CONSTRUCTION SUMMARY

Lindsay 2017 Developments Inc. / Sugarwood

Lot/Unit: 70 Phase/Building: 1 Model/Floor Plan: Silver Lake (3702) Elev A 3Bed 2.5Bath

Sketch #1

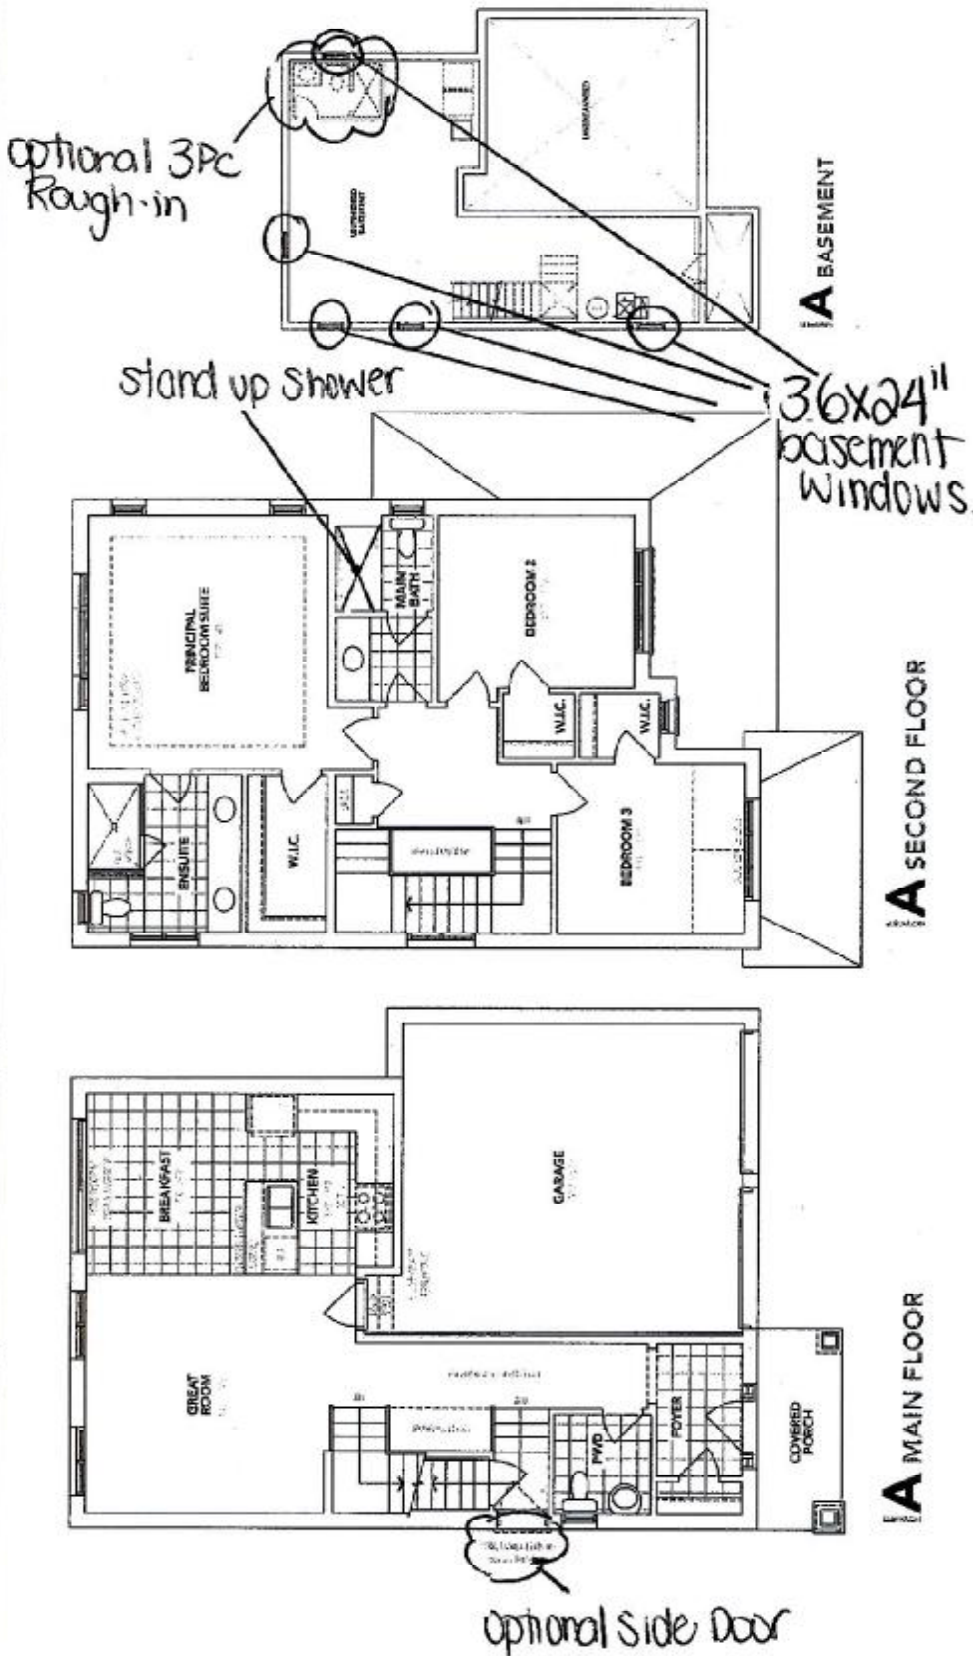
Inv.5943	1 - To supply and install the optional side door to the side of the home.. see sketch #1 for details	
Line 75274	Note:	
25Oct22 / 26Oct22		
Inv.5943	5 - To supply and install basement windows sized 36x24" in lieu of the standard size... see sketch #1 for details	
Line 75277	Note:	
25Oct22 / 26Oct22

Inv.5943	1 - To supply and install the 3PC Rough-in to the unfinished basement.. see sketch #1 for details	
Line 75273	Note:	
25Oct22 / 26Oct22		
Inv.5943	1 - To supply and install a stand up shower with frameless glass panel and door including a shower potlight to the main bathroom in lieu of the bathtub.. see sketch #1 for details	
Line 75275	Note:	
25Oct22 / 26Oct22		
Inv.5943	2 - To raise the toe tester in both the Master and Main bathroom shower to approx. 2 feet 7 inches up from unfinished floor in lieu of the standard height	
Line 75276	Note:	
25Oct22 / 26Oct22
